TO: Mayor John Ernst
ATTN TO: Aronda Smith, Senior Planner
FROM: Douglas R. Hooker, Executive Director
RE: Development of Regional Impact (DRI) Review

Name of Proposal: Lake Hearn (DRI #3133)

Description: A Development of Regional Impact (DRI) review of a proposed mixed-use project at 1396 and 1400 Lake Hearn Drive in the City of Brookhaven. The proposal would redevelop the 21-acre office site with 19,000 square feet of commercial space, 615 multifamily apartment units, and 5 acres of greenspace. The local trigger action is a rezoning from O-I (Office-Industrial) to MPD (Master Planned Development). Expected buildout is 2024.

Development of Regional Impact Assessment of Consistency with the Regional Transportation Plan

OVERALL
DRI SITE PLAN

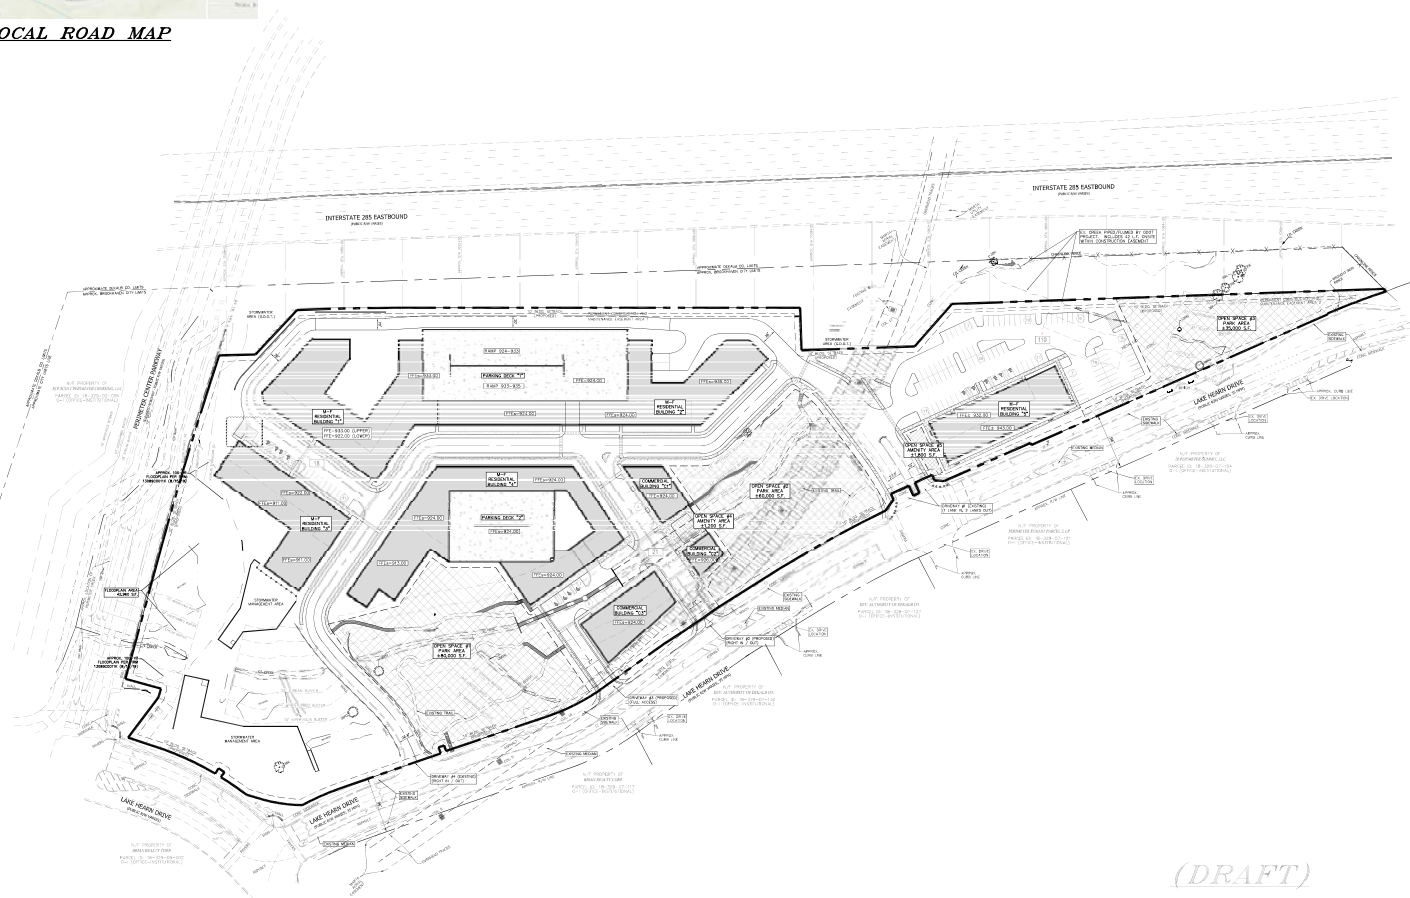
A challenge for pedestrians and cyclists heading north on Perimeter Center Parkway will be the proposed express lane off-ramp for I-285. This introduces a potentially unsafe pedestrian/motorist conflict even with a signalized crosswalk. The existing bike lane on Perimeter Center Parkway is minimal and appears to be in poor condition, next to multiple high-speed travel lanes. The existing pedestrian and bike routes to Medical Center station are currently inadequate and uncomfortable for most users, but ongoing redevelopment of the Peachtree Dunwoody Pavilion site (DRI #2590 in 2016) should shorten and improve this route as long as full public access is protected.

The project can further support The Atlanta Region's Plan in general by incorporating other aspects of regional policy, including green infrastructure and/or low-impact design, e.g., pervious pavers, rain gardens, vegetated swales, etc., in parking areas and site driveways, and as part of any improvements to site frontages. The DRI devotes a significant portion of the overall site to open spaces and park area, as well as stormwater management and stream buffer at the far southwest corner of the site. Please see the

attached comments from ARC's Natural Resources Group, which note that the site is located in the Nancy Creek basin of the Peachtree Creek watershed. It notes that variances may be required under the City's stream buffer ordinance and the State Erosion and Sedimentation Act.
